Re: Former Signal Oil Marine Storage and Distribution Facility
(Former Chevron Bulk Plant 20-6127)
2301-2311 Blanding Avenue
Alameda, California
LOP Case RO0002466

Re: Revised Sub-Slab Vapor Point Locations
Former Signal Oil Marine Storage and Distribution Facility
(Former Chevron Bulk Plant 20-6127)
2301-2311 Blanding Avenue
Alameda, California
LOP Case RO0002466

Subject: SLIC Case No. RO0002466 and Geotracker Global ID T06019744728, Park Street Landing 2301-2337 Blanding Avenue, Alameda, CA 94501

figure 1
SITE PLAN
CHEVRON 20-6127 - FORMER SIGNAL OIL BULK PLANT
2301-2311 BLANDING AVENUE
Alameda, California

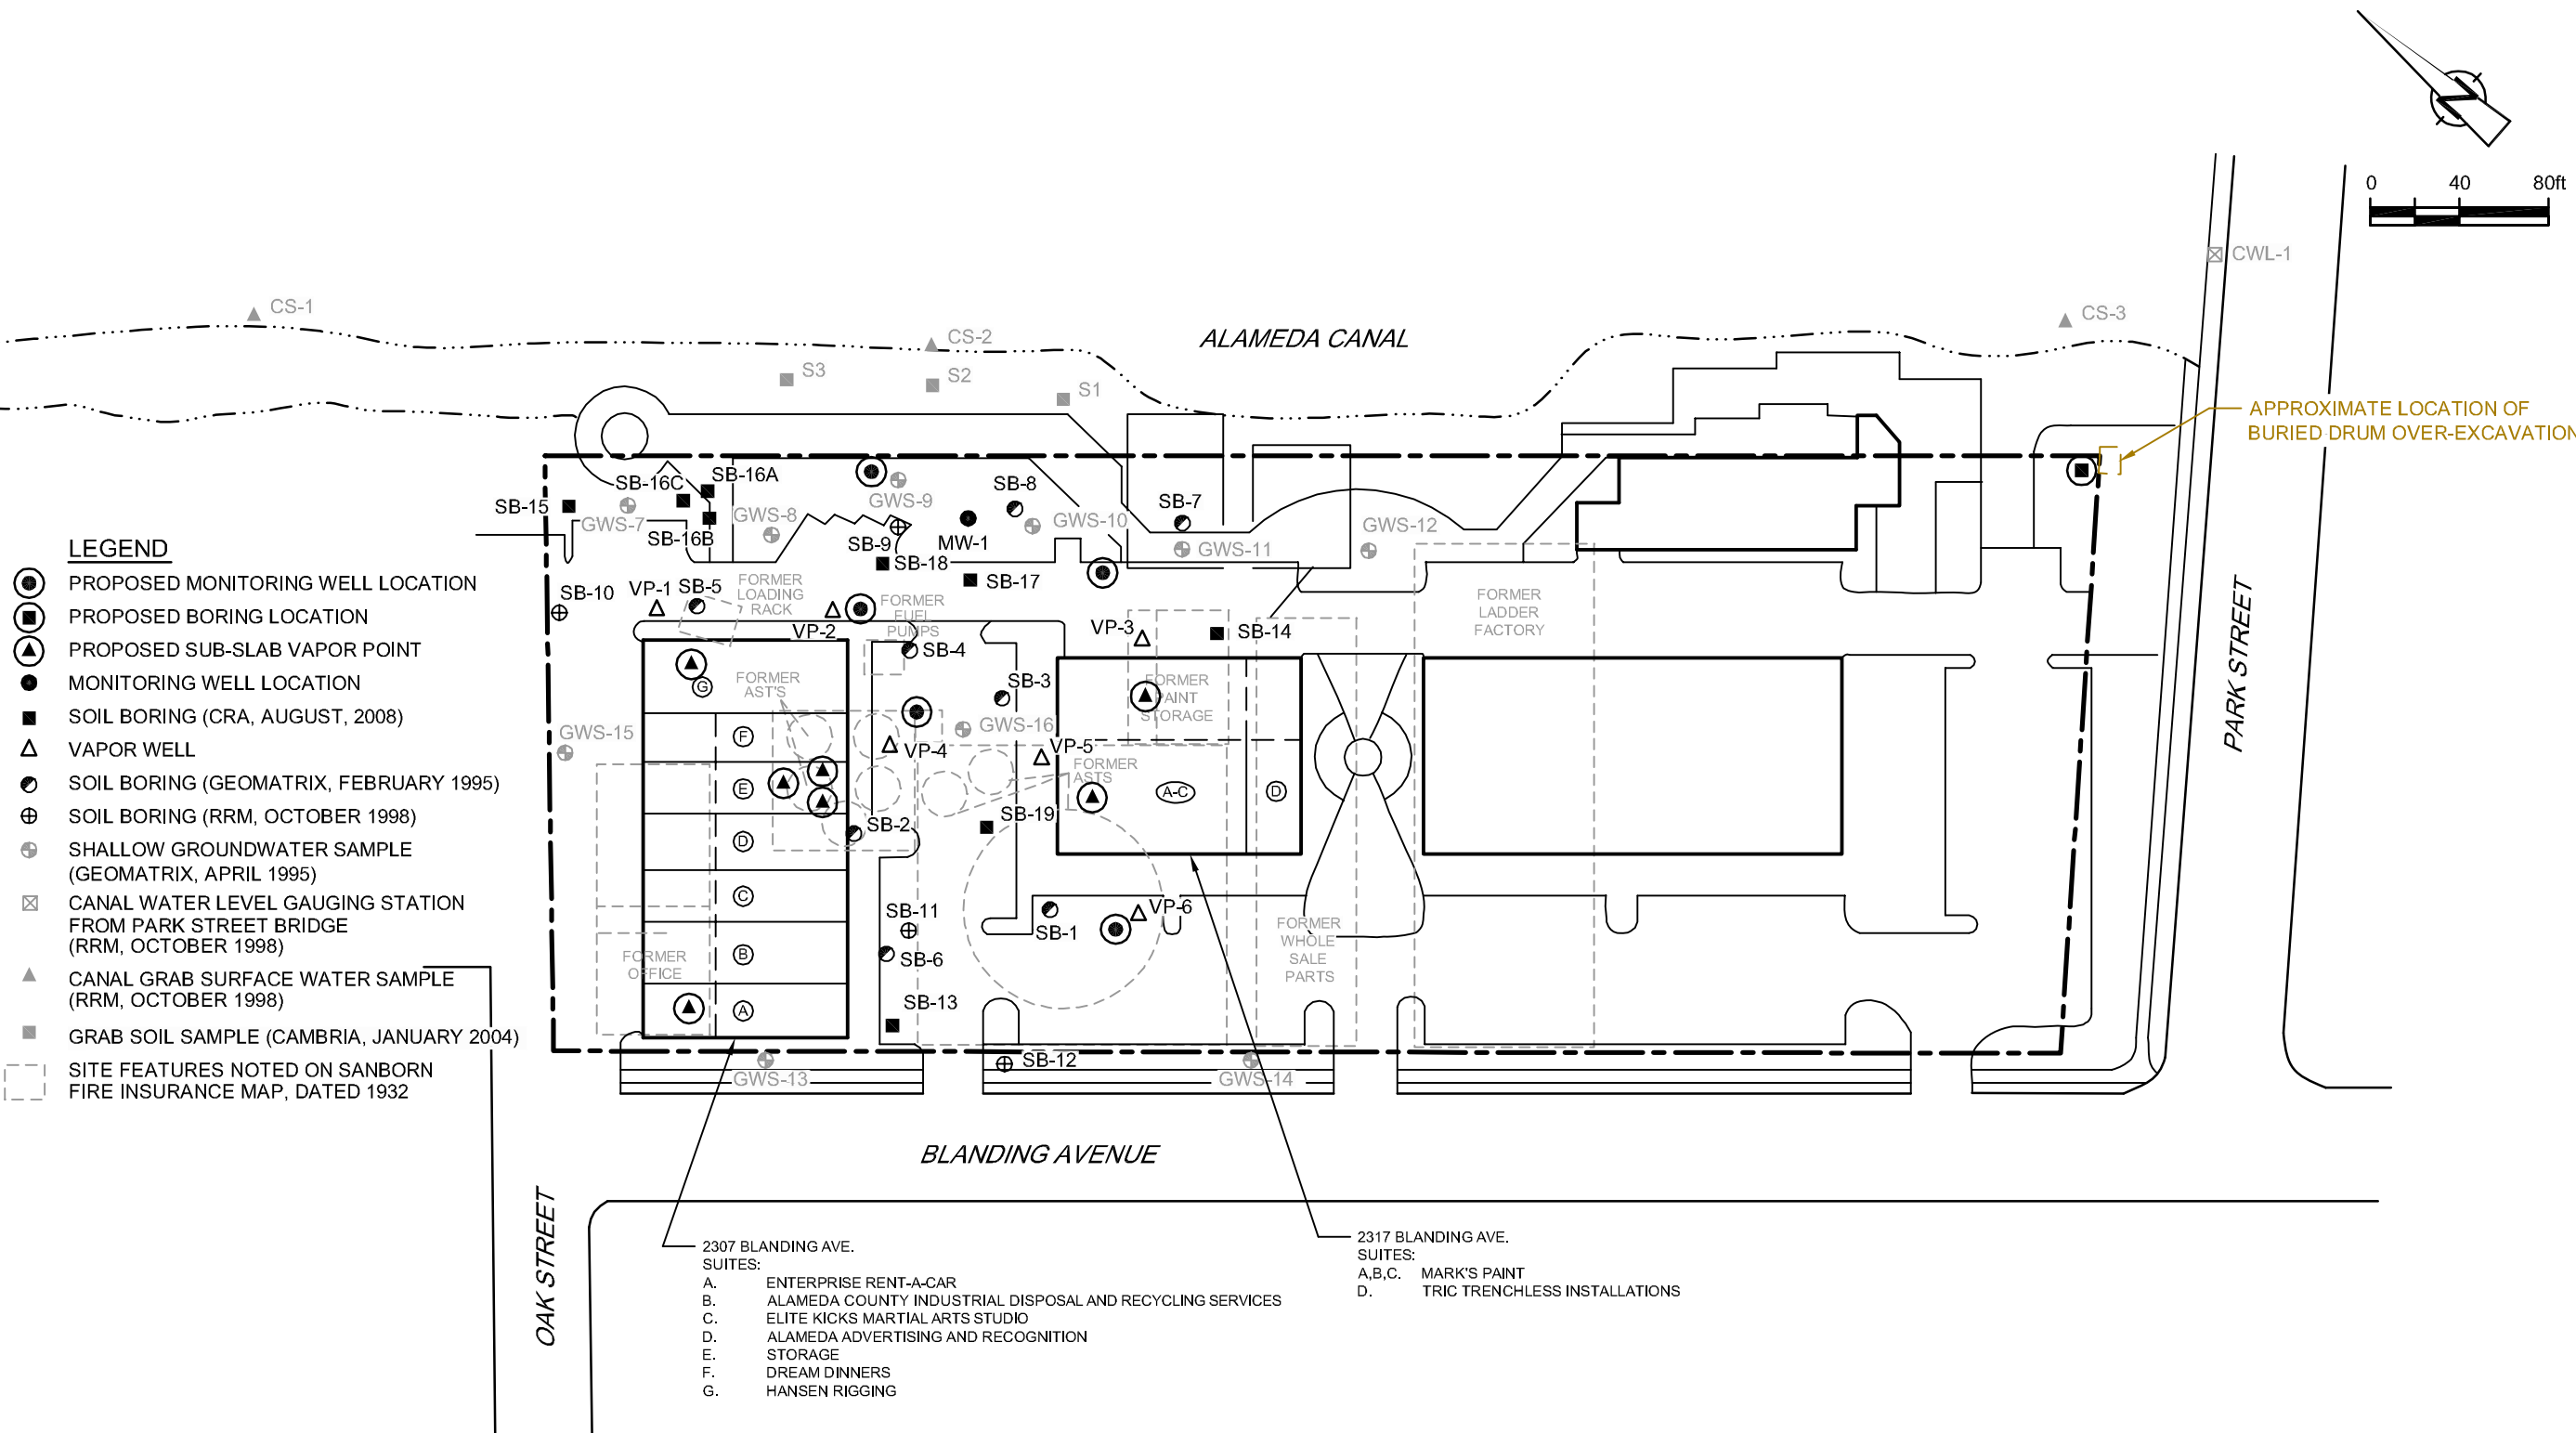
This letter documents our telephone discussion on June 24, 2009 regarding the sub-slab vapor point locations inside the building at 2307 Blanding Avenue, which is located on the site referenced above. As outlined in ACEH's correspondence dated June 19, 2009 (Attachment A), ACEH suggested alternate locations for the sub-slab sampling locations within Suites D, E and F at 2307 Blanding Avenue.

- The locations of the proposed sub-slab sampling points in Suites A and G will remain as originally proposed.
- The ACEH suggested alternate sub-slab vapor point locations in Suites D and F will be relocated to within Suite E adjacent to the interior walls. Suite E is not an active business and is only used for storage.
- One additional sub-slab vapor point will be installed in Suite E toward the center of the Suite (near the northwest extent of the former tank farm).

1. **Sub-Slab Sampling Locations for 2317 Blanding Avenue.** The proposed sub-slab sampling locations for 2317 Blanding Avenue are acceptable and do not require revision. Please present the results in the Site Investigation Report requested below.
2. **Sub-Slab Sampling Locations for 2307 Blanding Avenue.** The purpose of the proposed sub-slab sampling is to assess potential vapor intrusion to the on-site buildings. The potential for vapor intrusion must be evaluated within the occupied spaces adjacent to the locations where elevated concentrations of volatile organic compounds have been detected in soil gas. In particular, the occupied spaces adjacent to soil vapor sampling location VP-4 must be evaluated. The proposed sub-slab sampling locations for 2307 Blanding Avenue are apparently located in storage areas that

are outside the areas of concern. The nearest proposed sub-slab sampling location is approximately 80 feet from VP-4. Given that the contamination may be within the vadose zone, the proposed locations are too far from the suspected sources and occupied spaces to evaluate potential vapor intrusion for 2307 Blanding Avenue. Attachment 1 to this correspondence suggests alternate sub-slab locations that would be acceptable. Therefore, you may implement the proposed sub-slab sampling using the alternate locations shown on Attachment 1 or you may submit a Revised Work Plan Addendum by July 2, 2009 that proposes alternate locations that address the issues discussed in this technical comment.

The revised sub-slab vapor point locations as wells as the previously approved locations are shown on Figure 1, attached.
